"TERJE VIKEN"

SKETCH SHOWING ADDITIONS IN N° 2 CARGO

HOLD TO CONVERT SAME INTO

OIL FUEL BUNKER

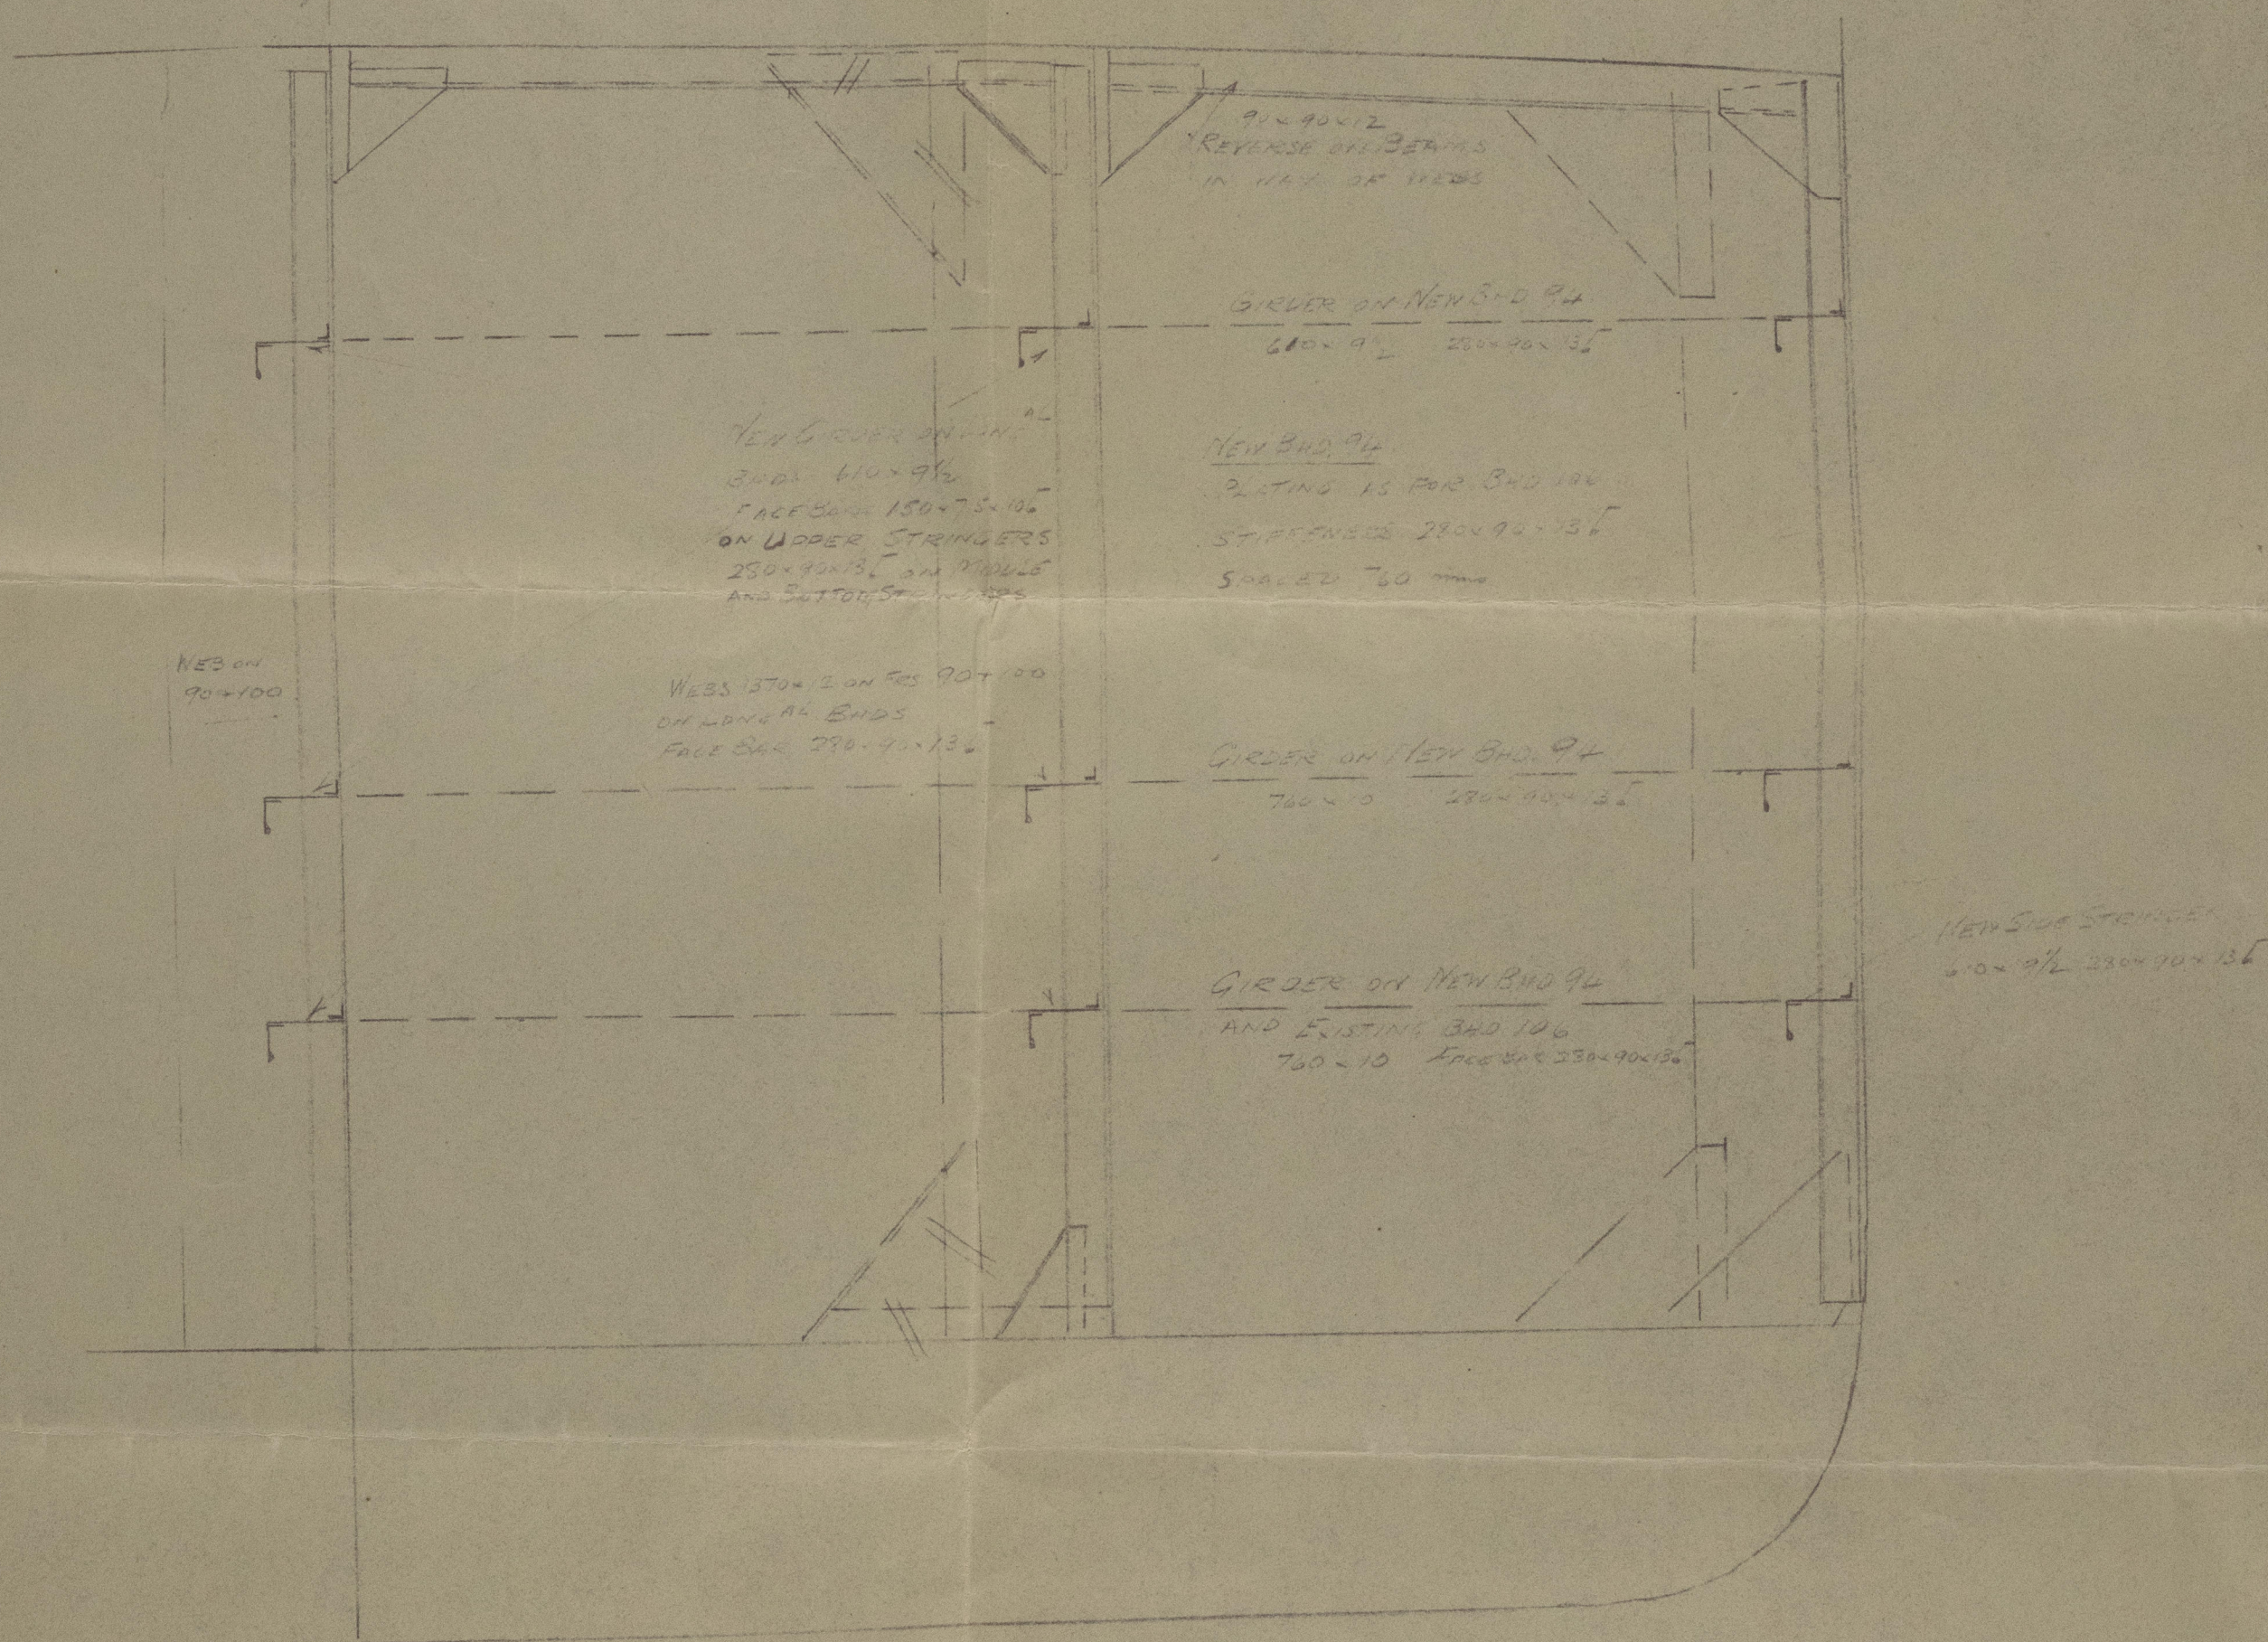
THE FLASH POINT OF THE OIL FUEL TO BE
CARRIED SHOULD BE NOT LOWER THAN
150°F AND THE REQUIREMENTS OF SECTION 20
OF THE RULES SHOULD BE COMPLIED WITH.
